**ADDENDUM No. 3 TO THE
FINAL ENVIRONMENTAL IMPACT REPORT
Carpinteria Valley Water District's
Water Storage Tank Project
And Rancho Monte Alegre Annexation**

September 12, 2007

PROJECT NO.
 03-039.01
 DRAWING NAME:
 SHEET 4 OF 8
 DATE:
 JUNE 18, 2007

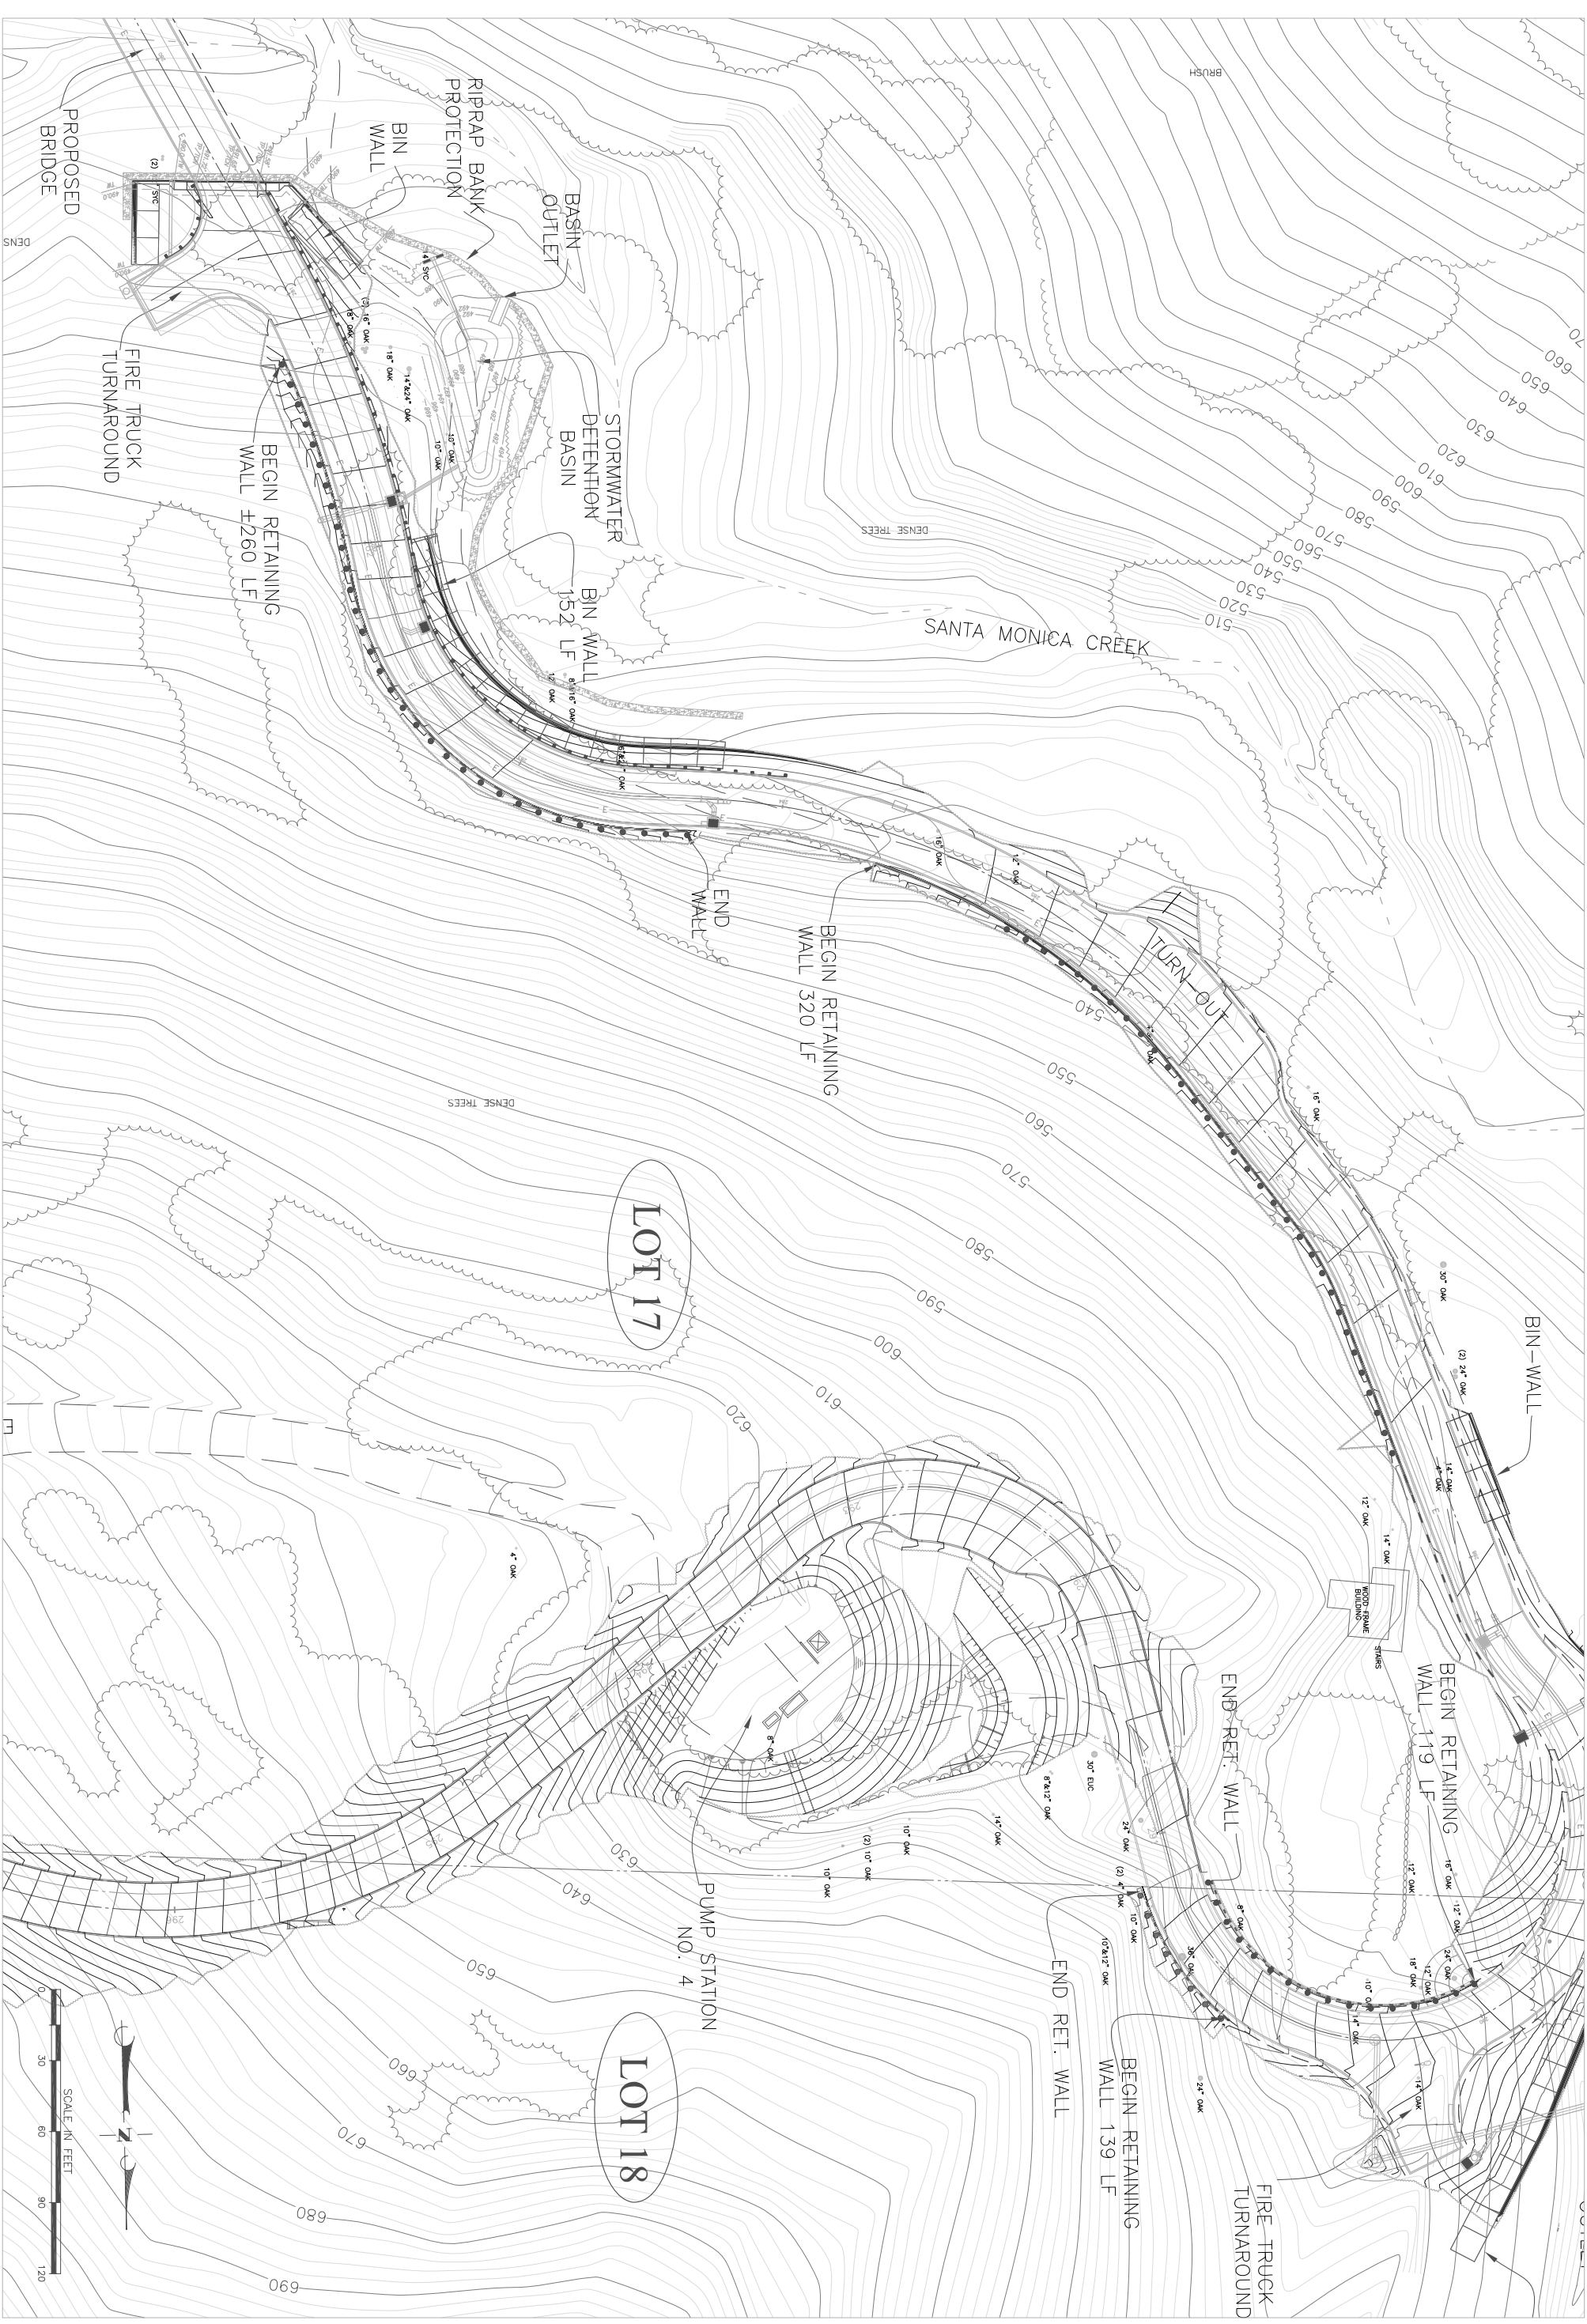
The Section F-F landslide area covers approximately a one acre area which straddles the terminus of Phase 4 and beginning of Phase 5 roadway and infrastructure improvements. (See Sheet 4 of 8 CVWD Phase 4 & 5 Upper Tanks Access Road RMA provided in the Attachments Section of the Addendum.) The land slide is described by Earth Systems (January 2007) as 290 feet long and 170 feet wide with the roadway improvements running south to north through the middle of the geologic hazard area. The overall depth of the slide area is estimated to range to about 60-feet, and is about 38 feet to 40 feet thick where it crosses the RMA access road.

The remediation for this landslide is stabilization of the slope with caissons in rows as shown on Carpinteria Valley Water District Phase 4 & 5 Upper Tank Access Road Rancho Monte Alegre Sheet 4 of 8 (see attachments to this addendum). Construction procedures will generally consist of (i) hand and dozer clearing of existing vegetation and removal of vegetation by dump truck; (ii) dozer grading to create caisson access paths for drill rigs; (iii) drilling of individual caissons; (iv) drilling of caisson tie-backs; (v) epoxy injection to secure tie-backs; (vi) placement of prefabricated caisson rebar cages; (vii) pour concrete to complete caisson construction; (viii) re-grading of access paths to restore to original grade, including replacement of top soil; and (ix) restoration planting of work area with oak woodland and native plants pursuant to restoration plan specifications. The duration for this construction activity is

The Section M-M area represents a hard rock formation with an existing slope layback of steeper than 1:1 horizontal slope ratio. (See Sheet 4 of 8 CVWD Phase 4 & 5 Upper Tanks Access Road RMA provided in the Attachments Section of the Addendum. This area is identified as the "Loose Rock Area" on the plan.) In some areas the rock slopes are near vertical. This formation is exposed above the proposed access road but is below ground surface below the access road at relatively shallow depths. The character of the formation consists of a large rock mass with multiple surface fissures and separations contributing to some areas of surface rock instability. The hazard created by this existing condition is that rock outcrops and fissured rock may separate from the rock mass and fall onto the road surface below. In addition, the slope face of the rock formation under some areas proposed for access road construction is so steep that construction access is impeded or construction costs for conventional caissons on the down slope side of the road is prohibitive. These conditions require the construction of a viaduct to span the excessively steep sloped formation.

PROJECT NUMBER: 12207B
 DRAWING NUMBER: 10-C-06
 SHEET NUMBER: 09 OF 88

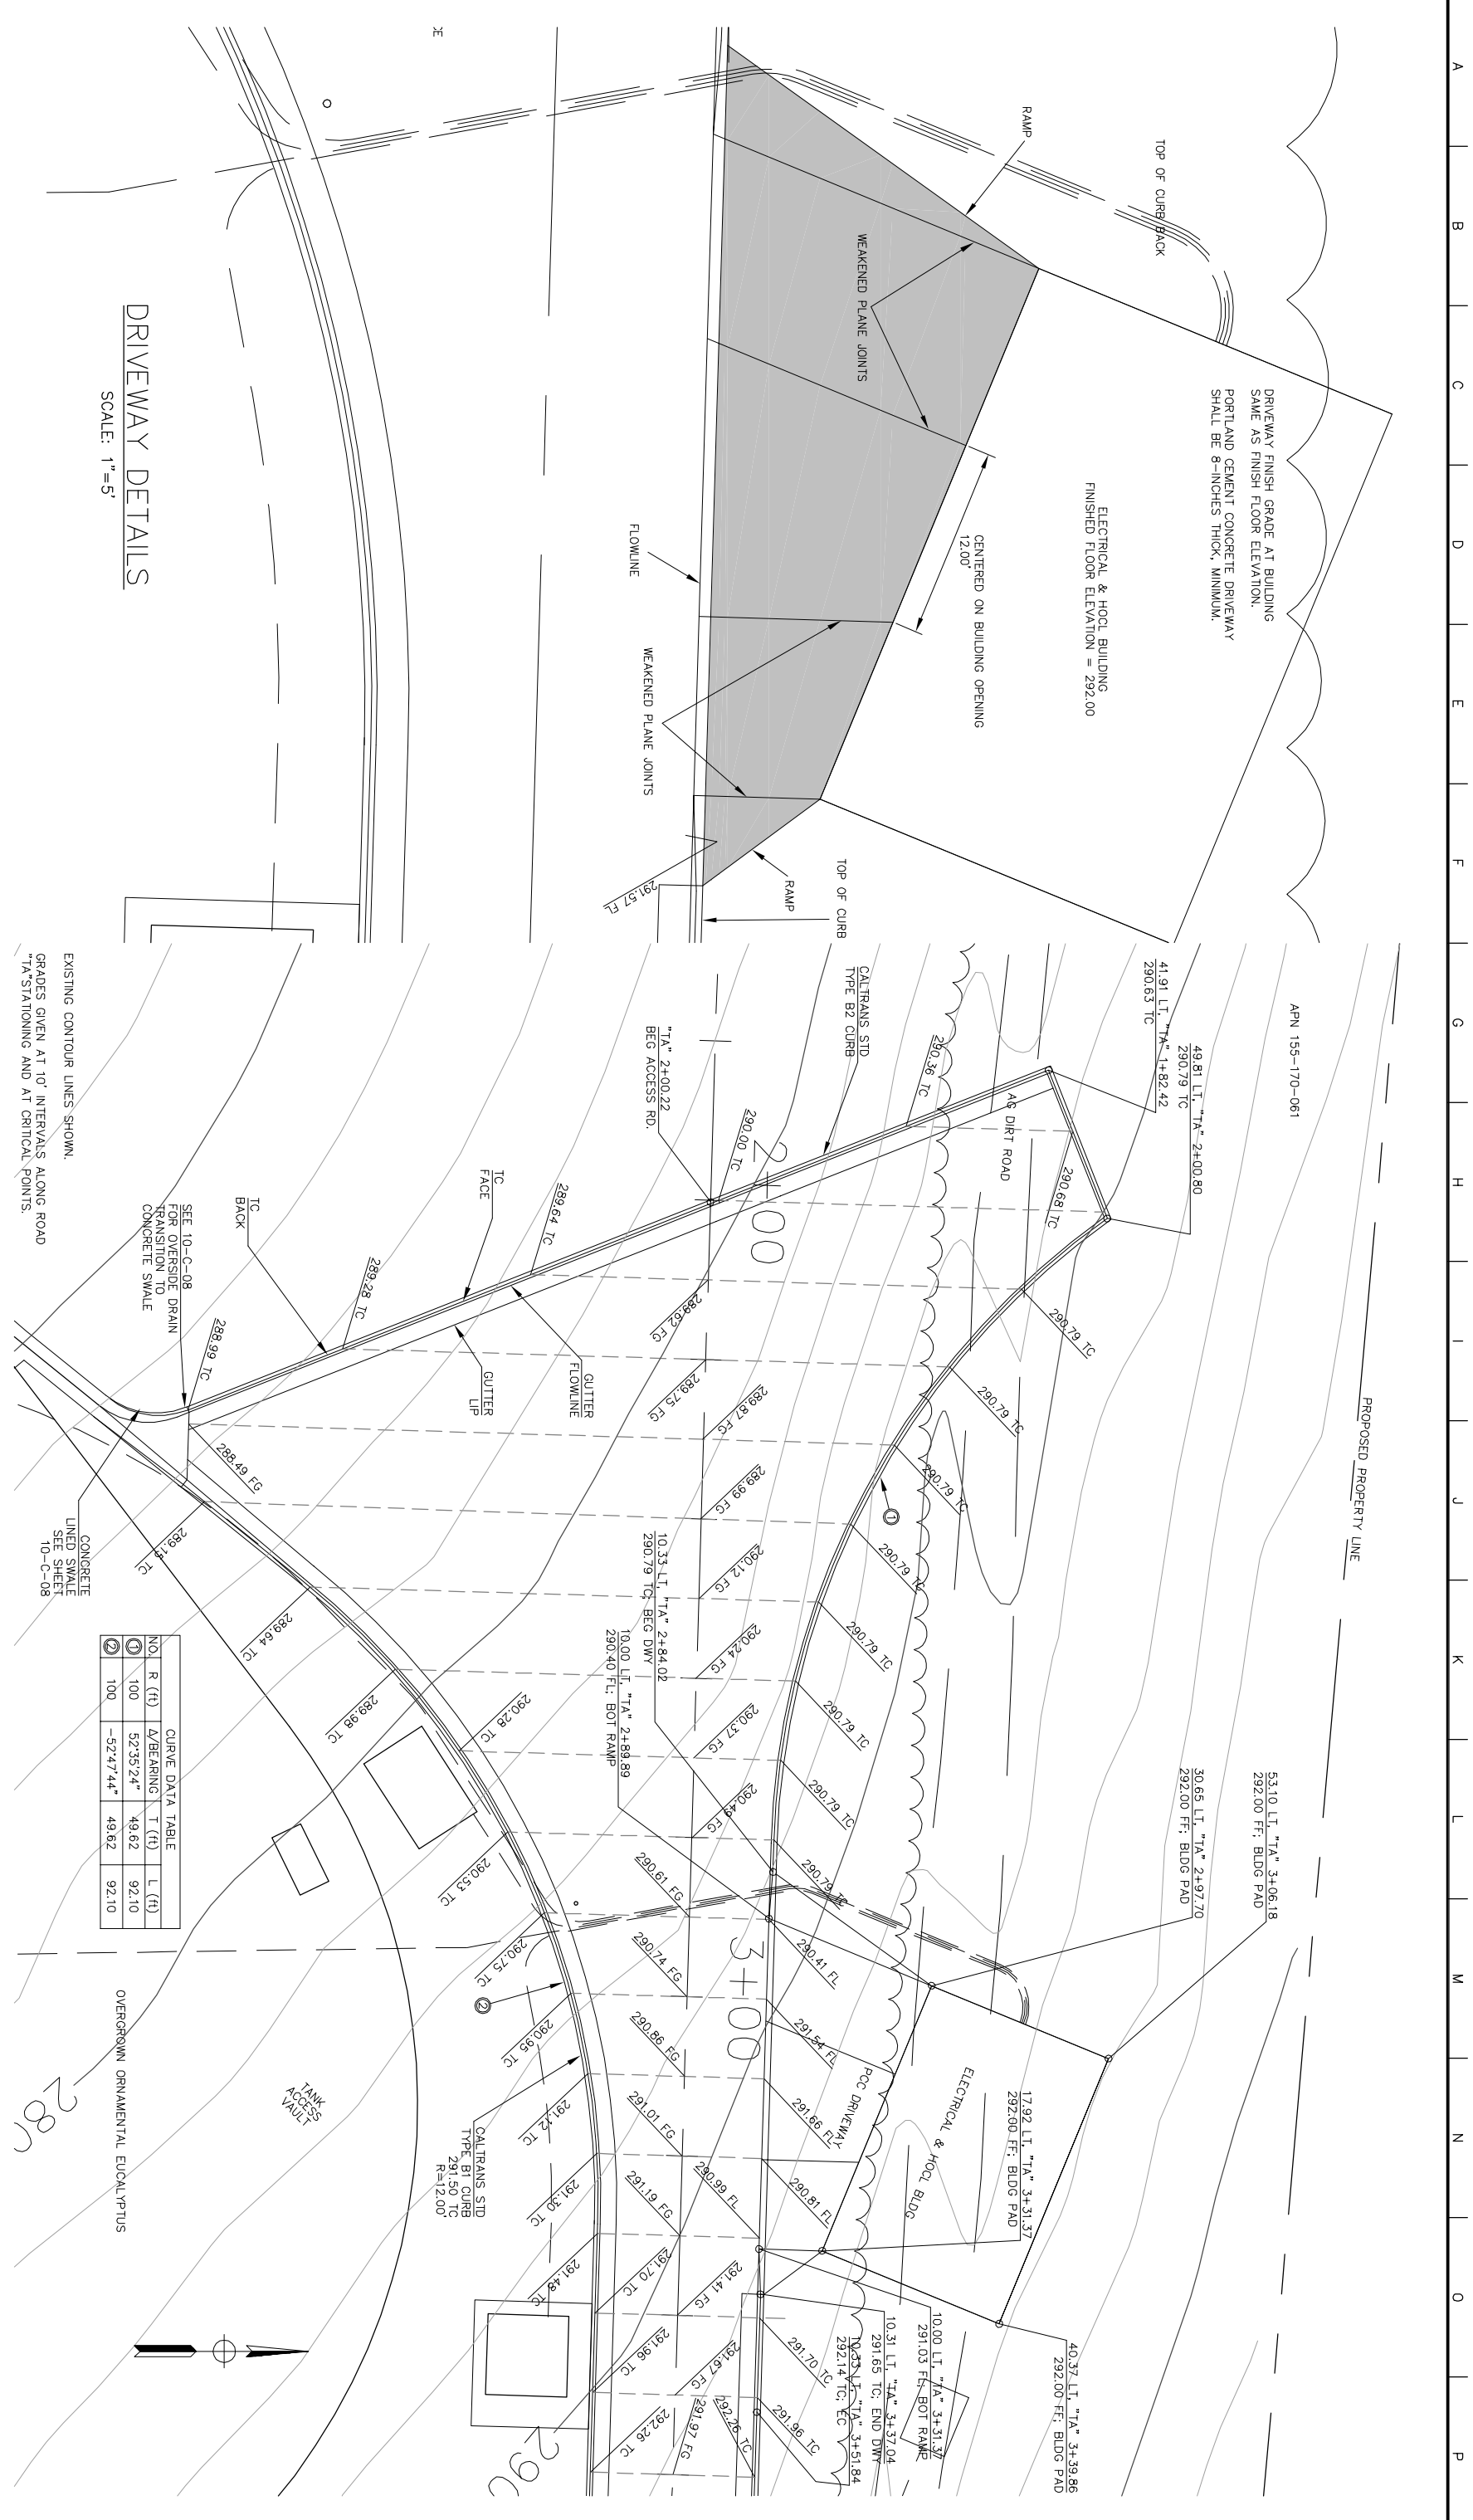
The project EIR included a short general description of the proposed 3.0 MG tank facilities, including a preliminary grading plan (Figure 3-5-1 of the FEIR1) which showed a tentative layout of the tank and related infrastructure and typical cross sections for the tank (Figure 3.5-2 of the FEIR). The District has slightly revised the site plan for the 3 MG tank. The revisions include elimination of a proposed clearwell² and reconfiguration of the Tank Access Road. As a result of the elimination of the clearwell and reconfiguration of the Tank Access Road, slight revisions to the layout of other proposed facilities were implemented. Please see the following related drawings:

- No. 10-C-06, Tank Site Grading Alignments and Layout
- No. 10-C-04, Tank Access Road turn-Around Construction Detail
- No. 10-C-07, Tank Site Sections
- No. 10-C-08, Tank Site Grading Details
